HISTORIC AND DESIGN REVIEW COMMISSION

Agenda Item No: 21

HDRC CASE NO: 2015-311
ADDRESS: 214 W LULLWOOD AVE
LEGAL DESCRIPTION: NCB 6533 BLK 13 LOT 29, AND 30
ZONING: R5 H
CITY COUNCIL DIST.: 1
DISTRICT: Monte Vista Historic District
APPLICANT: Adan Ochoa
OWNER: Michelle Nievaard
TYPE OF WORK: Amendment to New Construction of a Garage
REQUEST:

The applicant is requesting to amend a previously approved Certificate of Appropriateness at 214 W. Lullwood Ave. The requested design amendments include:

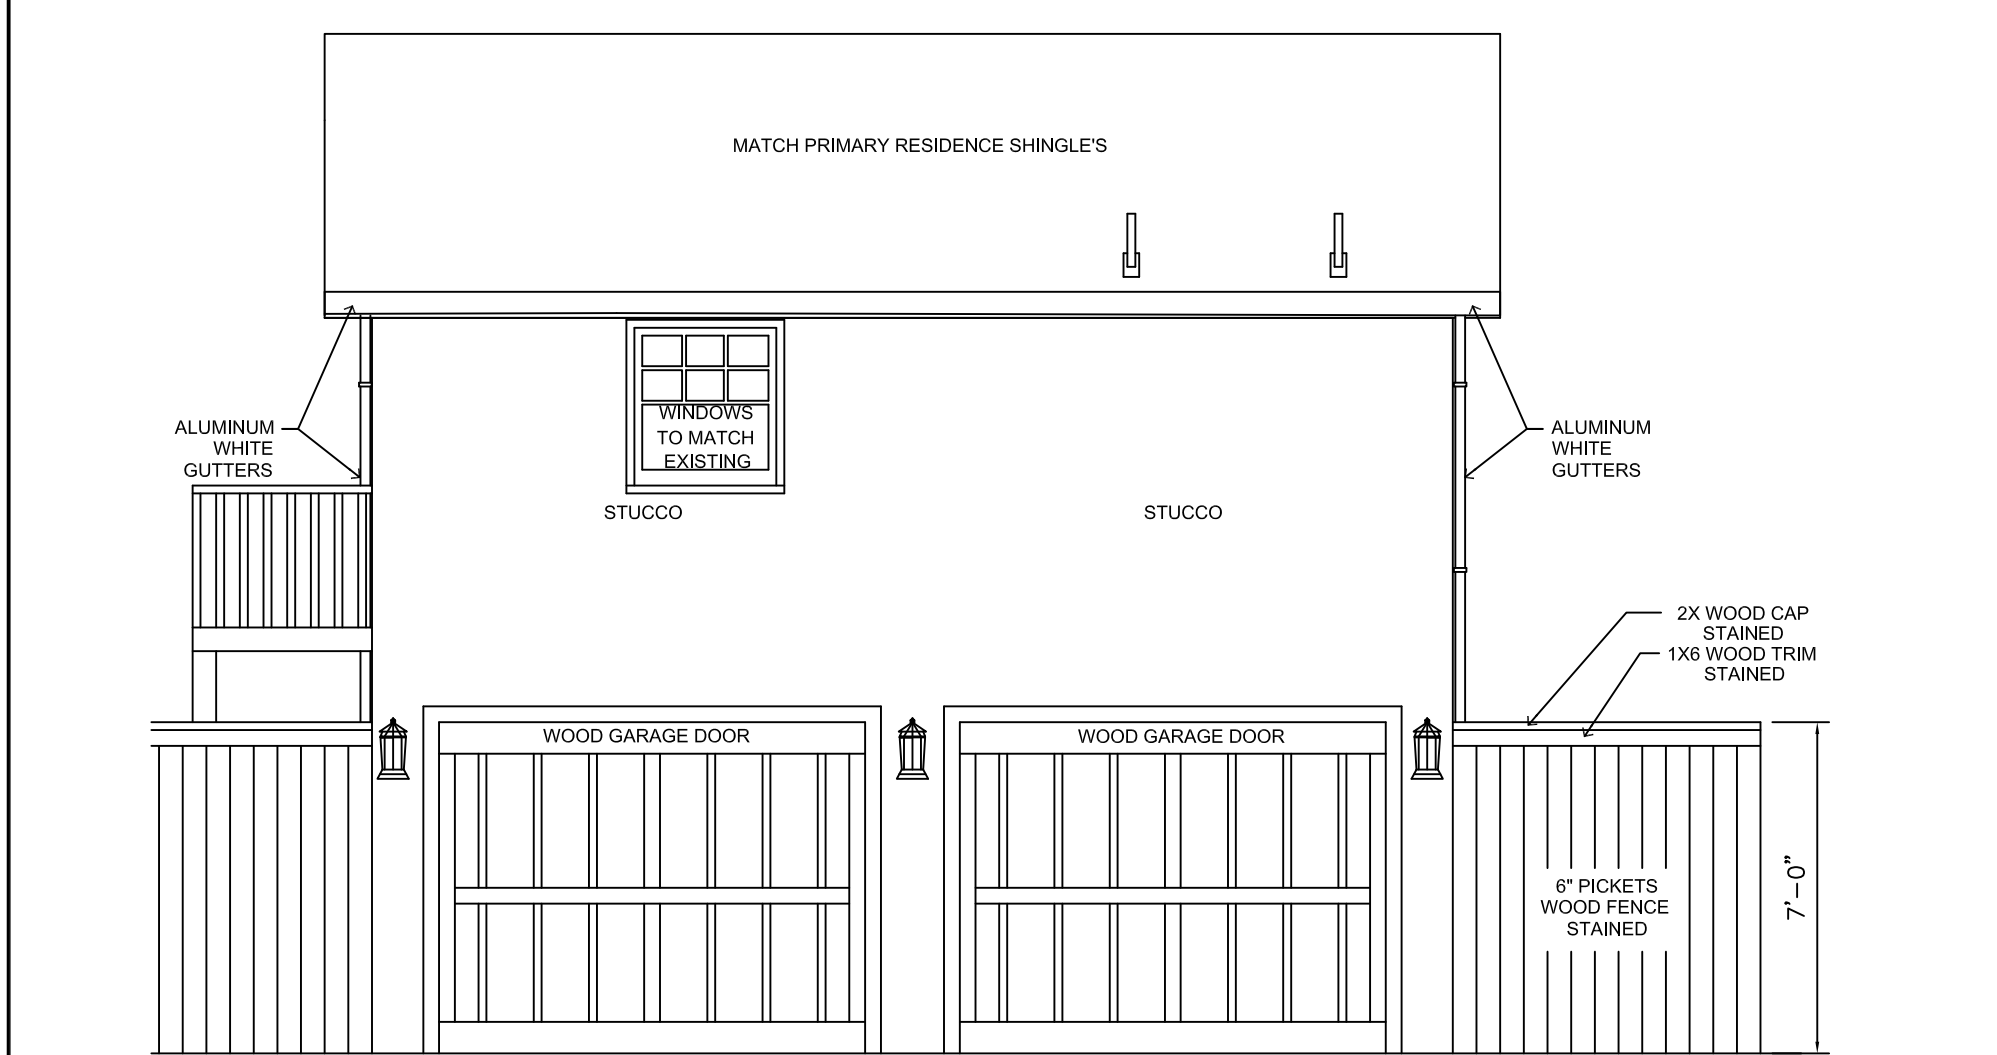
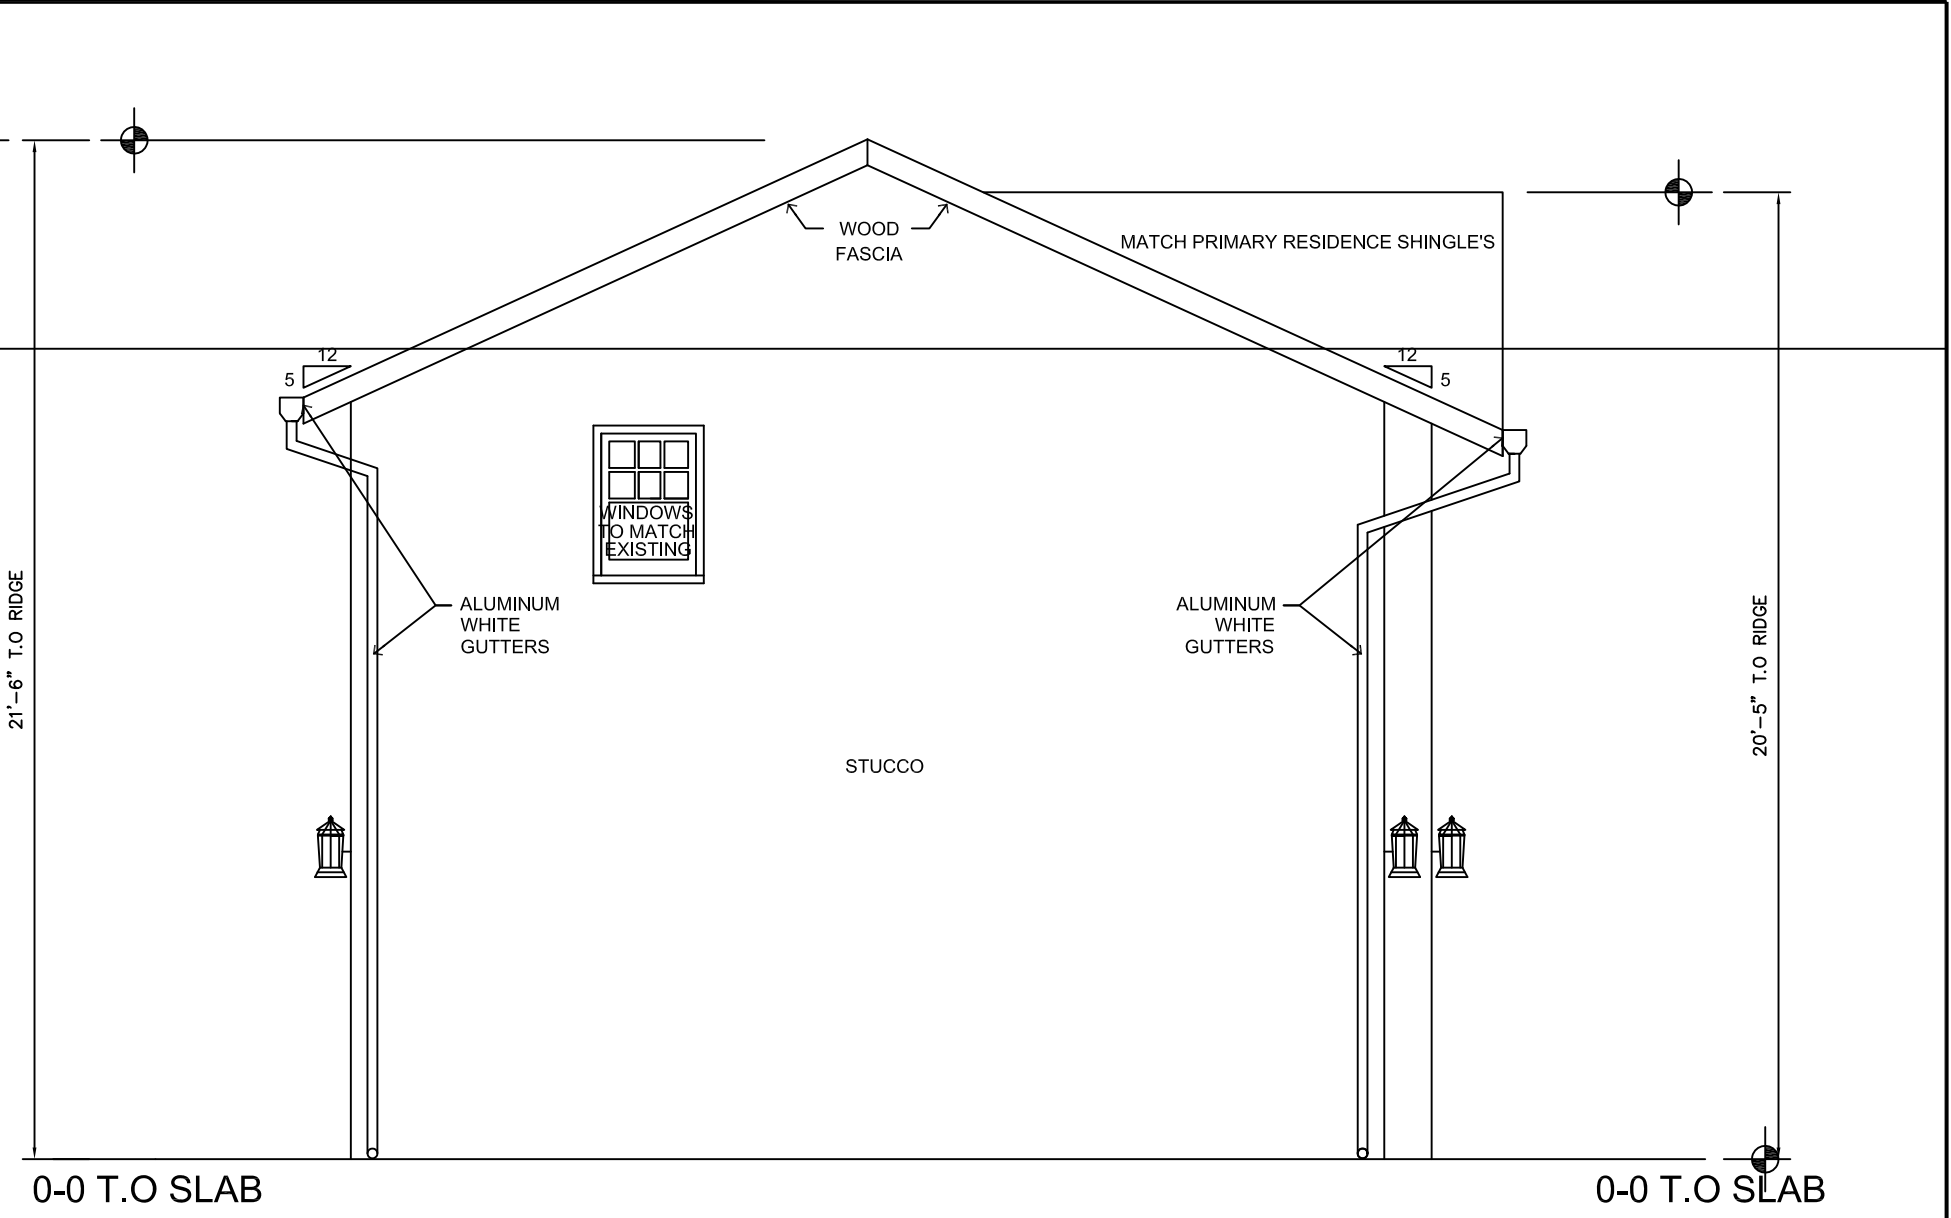
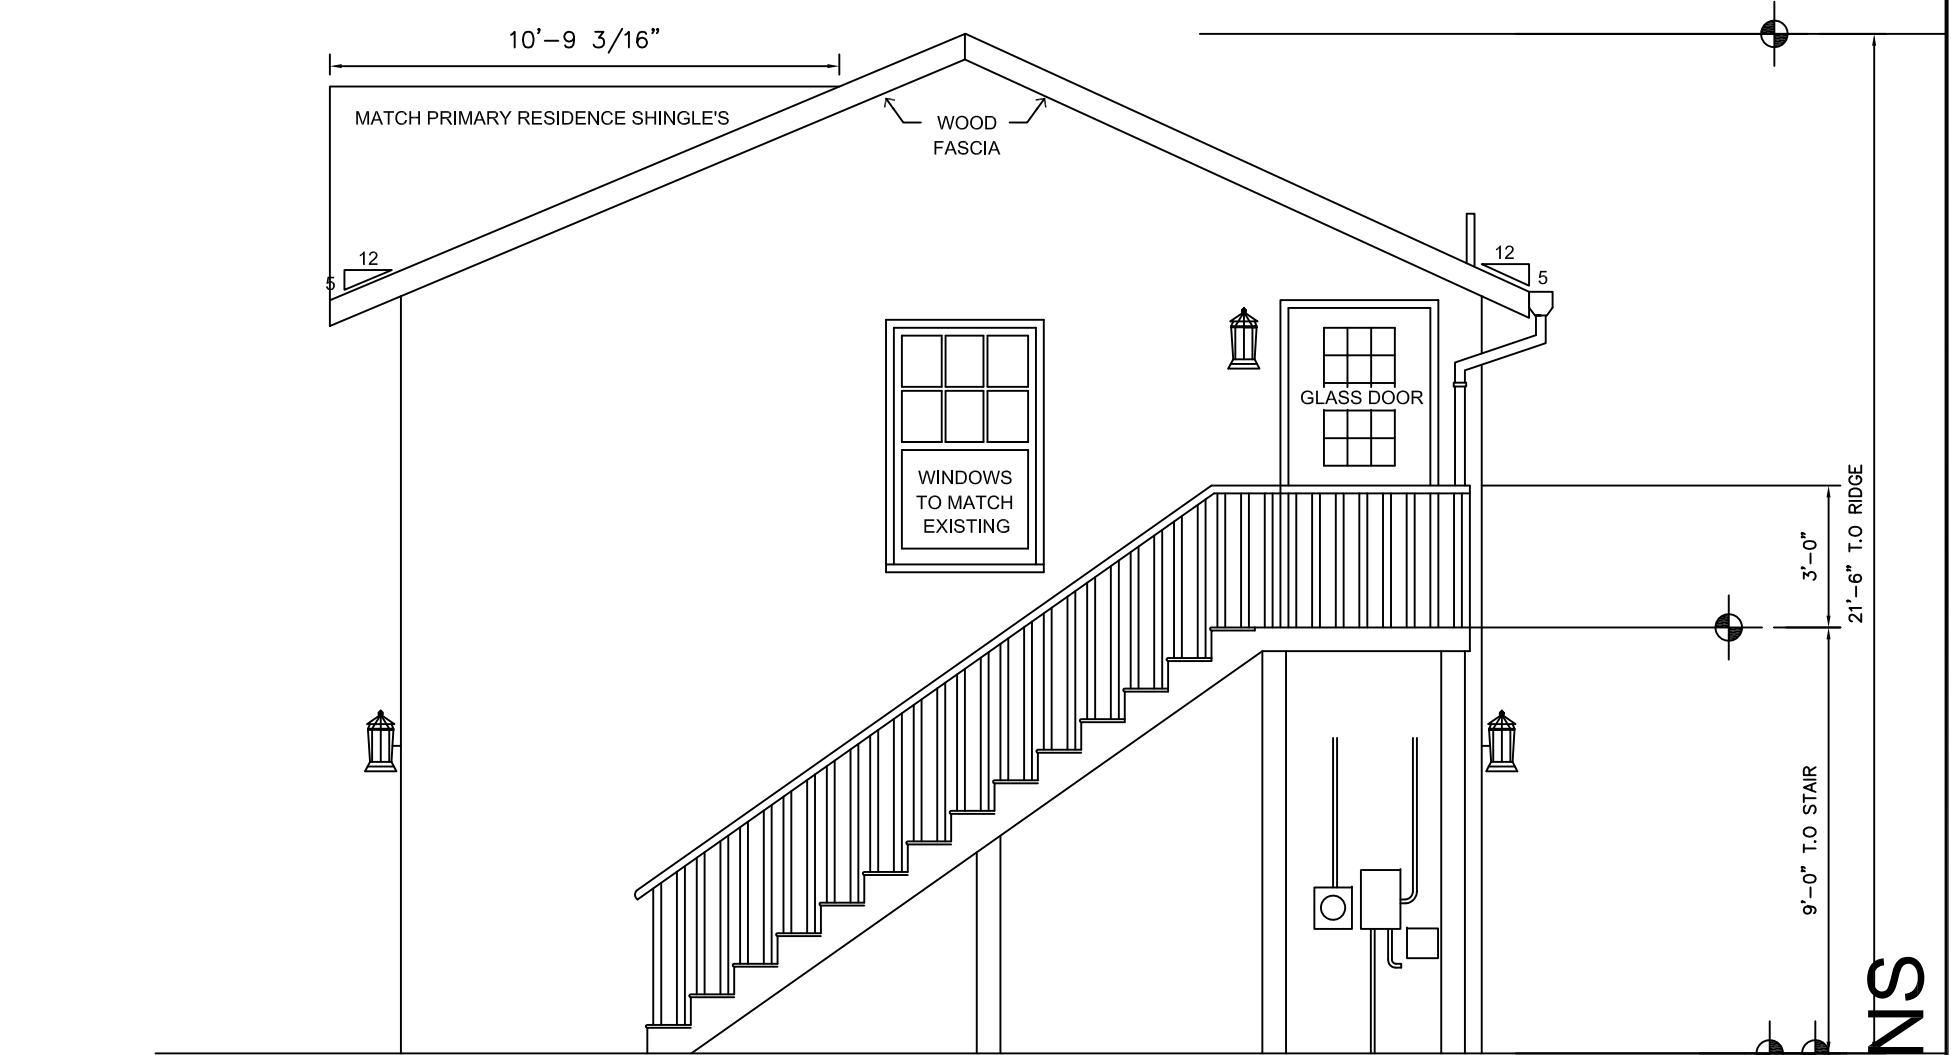
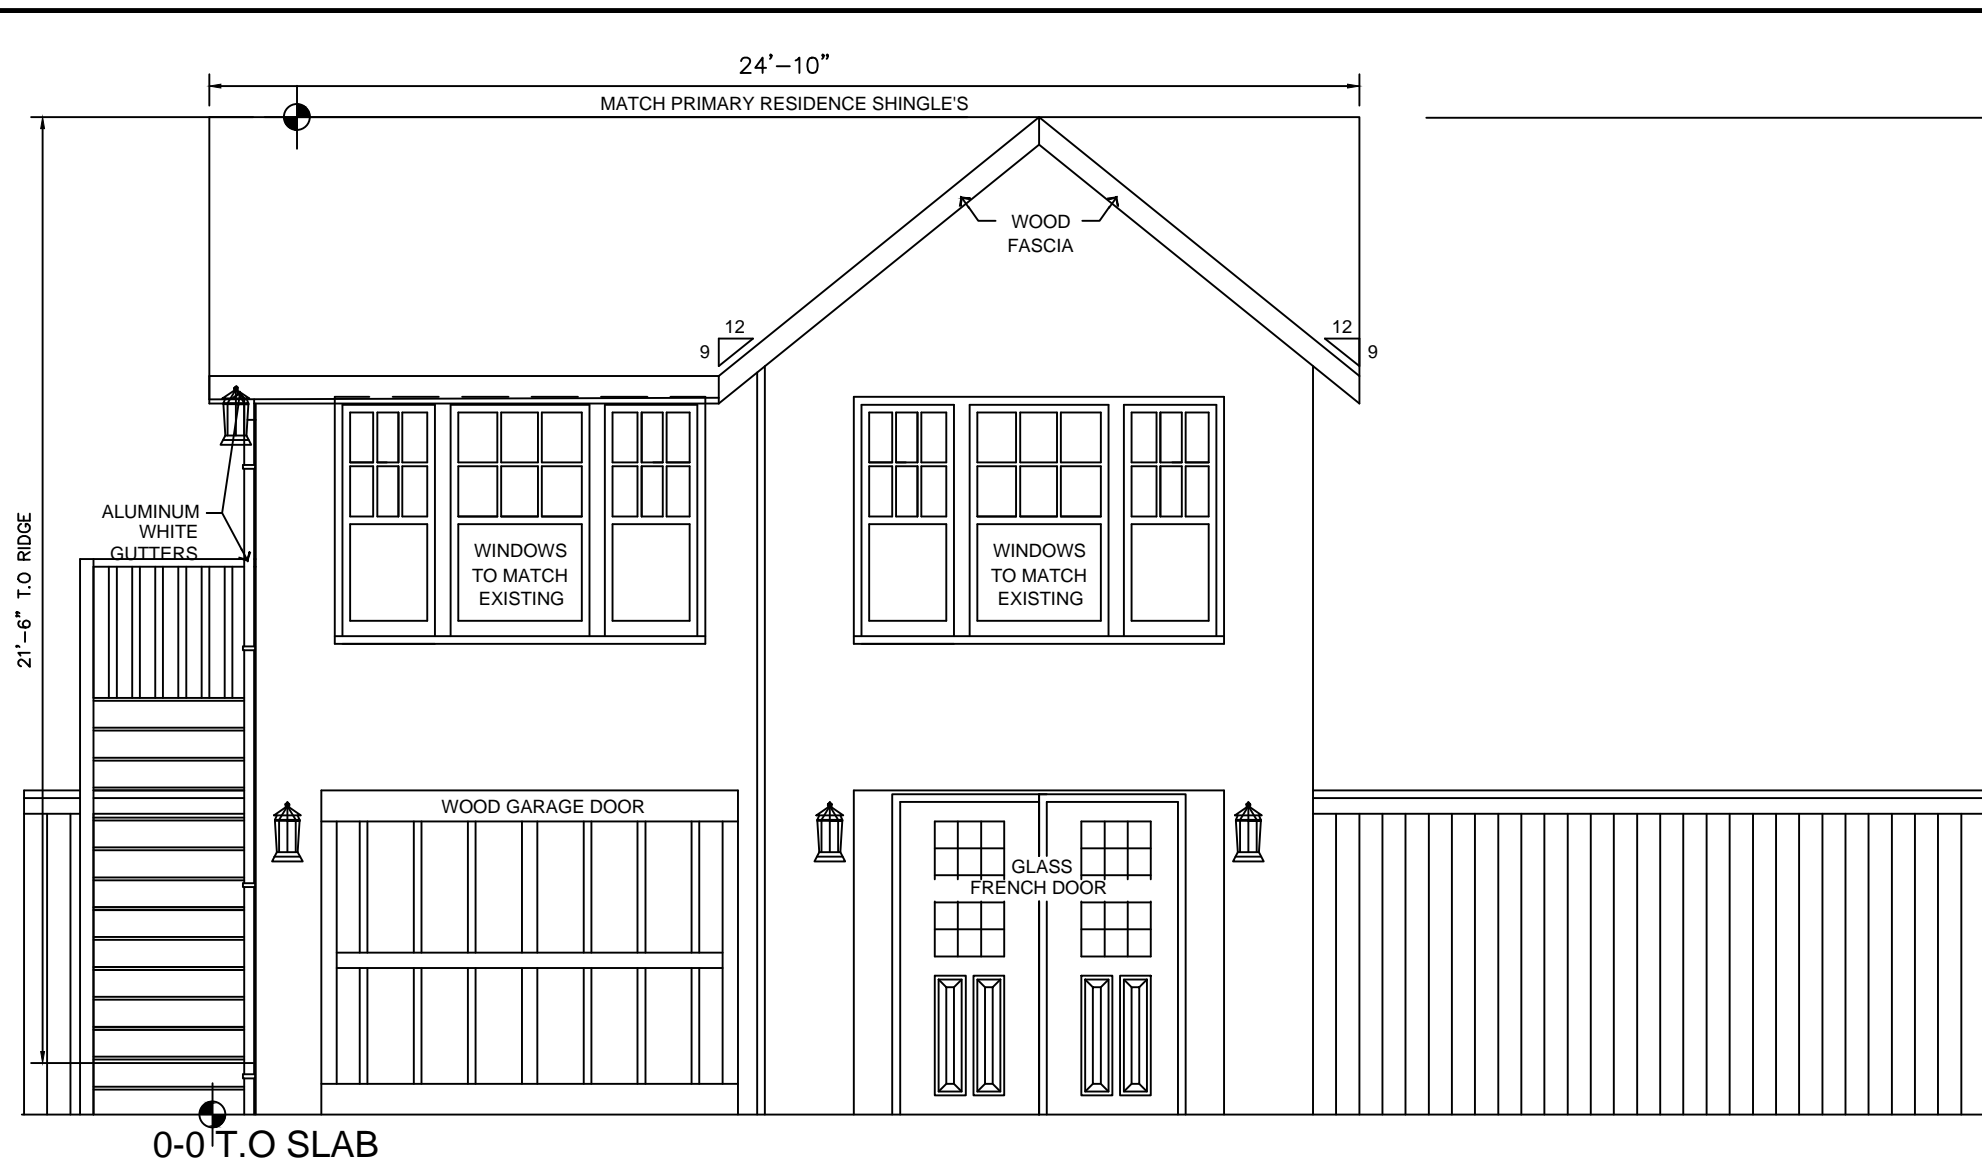
1. Moving the stairs from the west side of the structure to the east side.
2. Construct one garage opening (as opposed to two) along the alley.

- a. The applicant received approval from the HDRC for demolition and new construction of an accessory building on May 4, 2014.
- b. Consistent with the design guidelines for new construction of garages and outbuildings 4.B.i., the proposed location of the exterior stairs is appropriate and compatible with the building's orientation.
- c. The proposed garage door configuration will not feature appropriate proportions that are typically found in the district. This is not consistent with the design guidelines for new construction of garages and outbuildings 5.A.3 & 5.

Staff recommends approval of item 1 based on finding b. Staff does not recommend approval of item 2 based on finding c.
